GAINES CHARTER TOWNSHIP
PLANNING COMMISSION – REGULAR MEETING
Township Board Room - 8555 Kalamazoo Ave. S.E. Caledonia, MI 49316

Planning Commission Memo

Re: DGX2 Plan Review

RE: Amazon Delivery Station – Site Plan Review
Section 1, Gaines Charter Township

DX2 SOUTHWEST LANDSCAPE PLAN

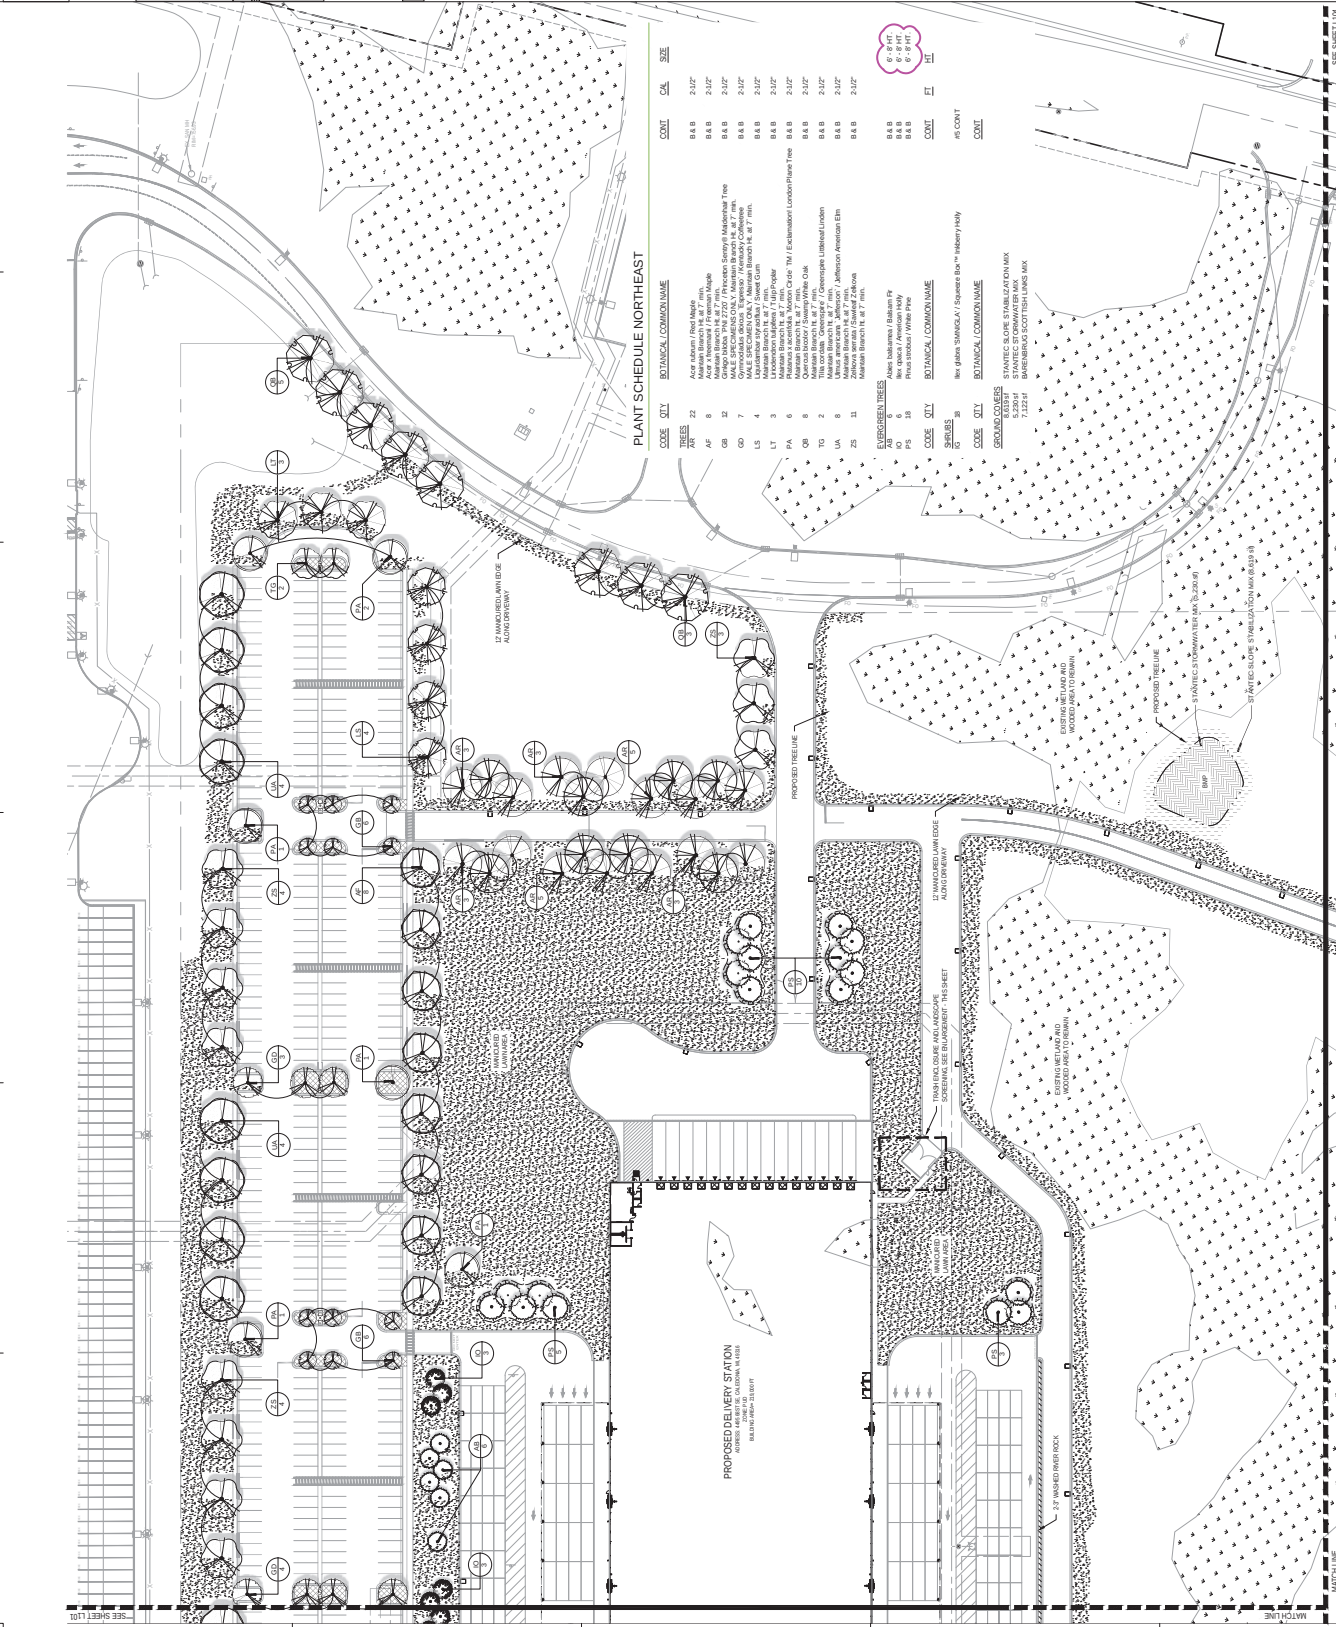
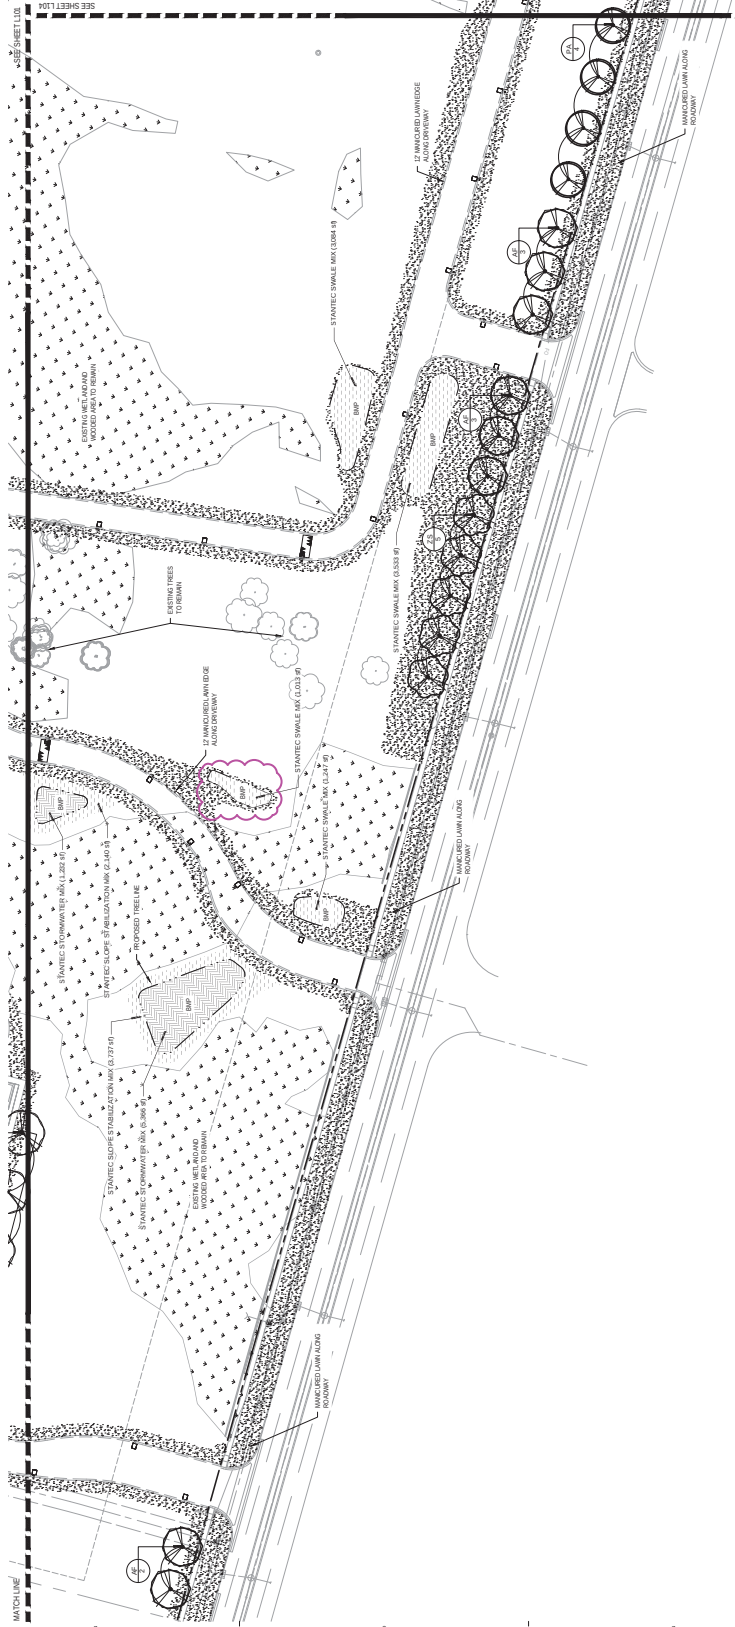
7. With regard to installation sizes for landscaping, 23.30.E.7 stipulates that evergreen trees must be installed at a size of no less than 6 feet; I see on the site plans that balsam firs are noted as being 5 feet upon installation.

Progressive Companies Response: All evergreen trees are to be 6-8 feet tall at installation. The plant schedules have been adjusted accordingly.
